25 July 2024
Ref: 242059.4L
Prity Cleary
Senior Planner
Department of Housing Planning & Infrastructure
Via NSW Planning Portal

[Submission for SSD69615996 - Mixed use development including infill affordable housing - Victoria Street and George Street, Burwood](#)

We have reviewed the SSD and provide this submission objecting to the SSD. The SSD as currently proposed contains a number of errors and is accompanied by insufficient information to properly assess the potential negative impact on the Club and surrounding area.

Figure 2 - SSD Depicted with Height Planes (source: The Applicant: Urban Link; dated 2024)

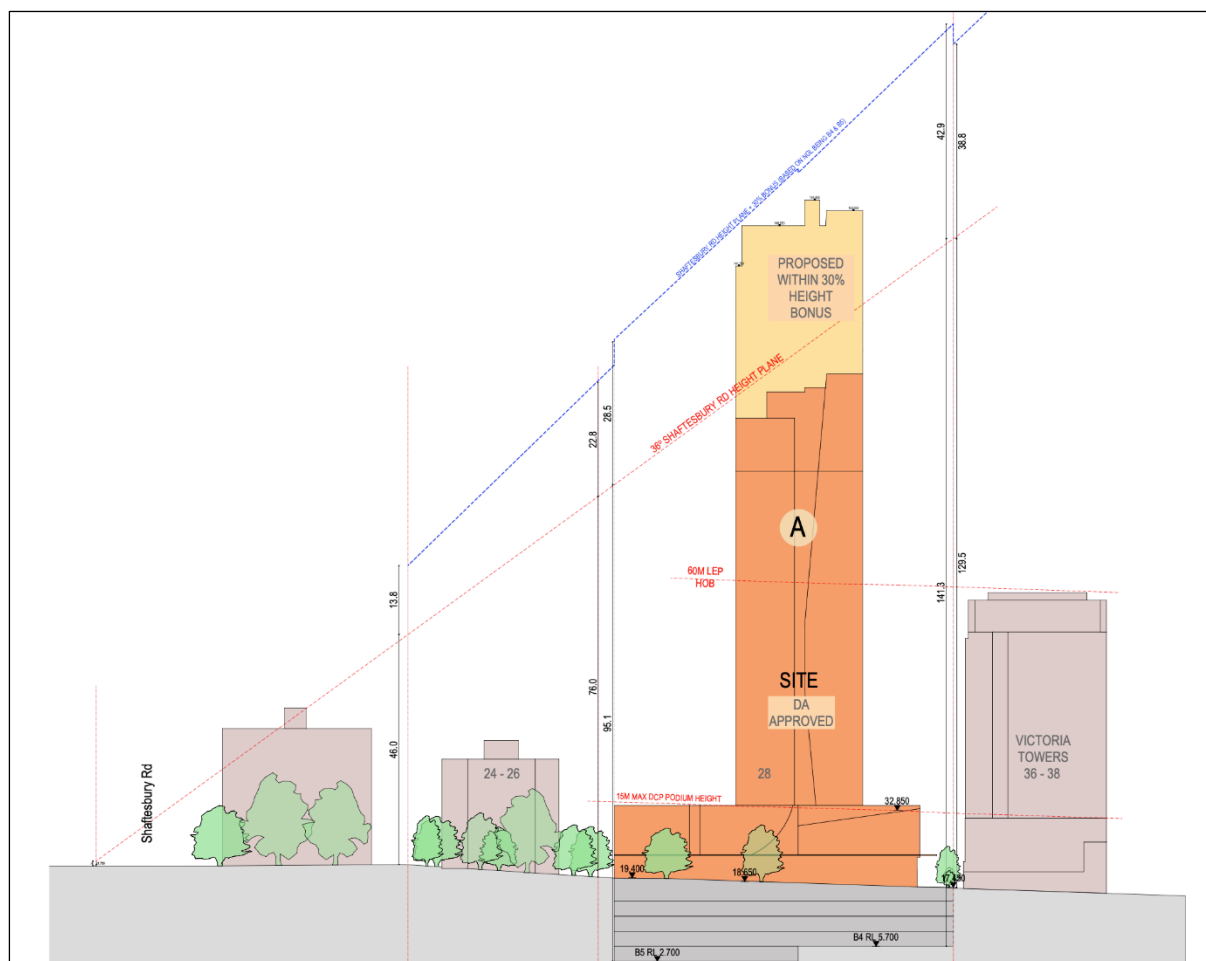
The SSD proposes a height of 136.73m, 110.3m, and 83.35m at 28-34 Victoria Street, 21 George Street, and 17 George Street respectively, which it says complies with the maximum building height subject to additional height available under the State Environmental Planning Policy (Housing) 2021 (**SEPP (Housing) 2021**). That is shown in the **Figure 2** below. However, the Application advances on an incorrect basis.

The Applicant has applied the 30% SEPP (Housing) 2021 variation to the **building height plane** under cl 4.3A, which is an environmental ground for exception to the **maximum building height** under cl. 4.3. It is as absurd as adding 30% to the maximum variation achievable under cl. 4.6 on environmental planning grounds. The building height plane is not a **development standard** as defined in the EP&A Act because it does not fix a standard and so cannot be relied upon to define the maximum permissible building height for the purpose of SEPP (Housing) 2021.

The Applicant's submission and legal advice proceeds on the basis that '**maximum permissible building height**' is defined under cl 4.3A 'Exceptions to Height of Buildings' of the LEP. To do so, leaves cl 4.3 'Height of Buildings' with no work to do whatsoever and ignores the objective of that provision. As a matter of statutory construction, that cannot be correct. The building height map clearly shows that both provisions apply. So, it cannot simply be a matter that cl. 4.3A automatically prevails.

The maximum building height for the purpose of SEPP (Housing) 2021 is therefore 60 metres plus 30%, or, 78 metres. Any additional height would require the support of a clause 4.6 variation request for the consent authority to be empowered otherwise than to refuse development consent.

Figure 5 - Maximum Building Height Map (Source: Burwood LEP 2012; accessed 24 July 2024)

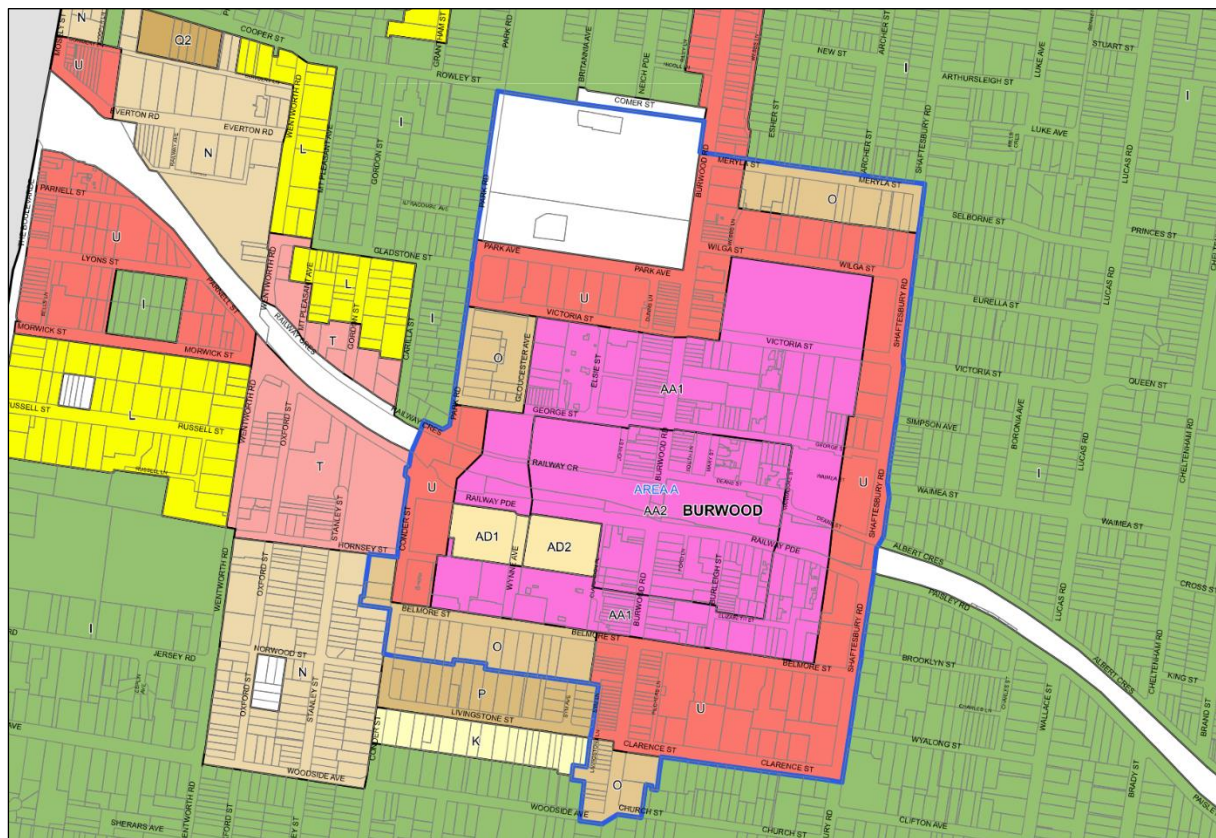
There is a potential conflict between these two provisions.
